Re: Planning Permit Application No. DC/153/2024 46-50 High Street, Bendigo

Glossop Town Planning continues to act on behalf of the Roman Catholic Trusts Corporation in relation to the above planning application.

Further to Council's letter dated 30 July 2024 and our subsequent meeting of 13 August 2024 please find enclosed:

## Activation at street level at High Street façade

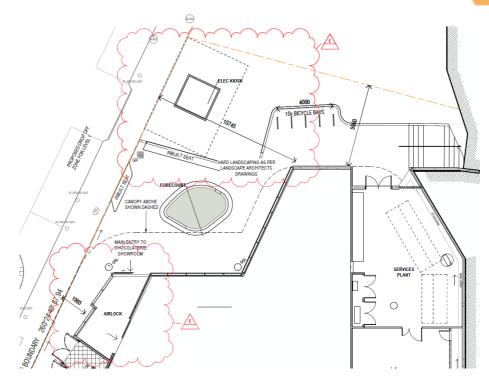
- a-d) The layout of the public forecourt has been further adjusted to optimise the experience of the public realm by future users. Most notably:
  - The delineation between the pedestrian traffic areas and landscaped areas has been adjusted to allow for improved pedestrian flow.
  - Similarly, the positioning of the central landscape island has been adjusted to provide even spacing either side for pedestrian movement.
  - The recess to the services plant entry has been decreased, but remains still behind the adjacent building line, to remove any perceived safety risk.
  - The location of the bicycle parking area has been shifted to allow greater visibility from internally within the building and to ensure it does not impede pedestrian movement. Two bicycle spaces have also been relocated to Level 2 to assist with this outcome.

These adjustments to the forecourt layout will all improve the pedestrian experience and allow for improved flow through, and perceptions of, the forecourt.

## Forecourt area/ publicly accessible outdoor space

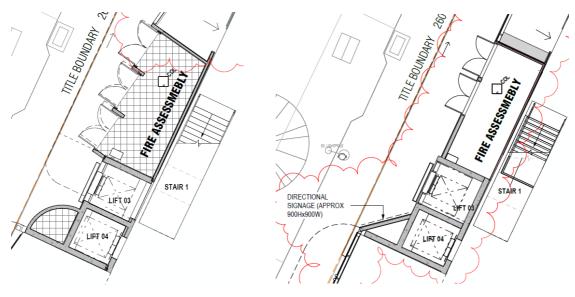
a) An approximately 0.81 square metre directional sign is proposed along High Street adjacent public lift 3 to provide information regarding the tenancies within the building and make clear that the lift leads to the public terrace at Level 3.

To improve the visibility at street level of public lift 3, the adjacent fire assembly has been pulled back inline with the lift and the curved wall protruding adjacent lift 4 splayed.

As per the discussions held at our meeting, the upper level prominence of public lift 3 has also been increased to improve the understanding of the 'journey' principally through the amendment (reduction) of the Level 3 balustrade.
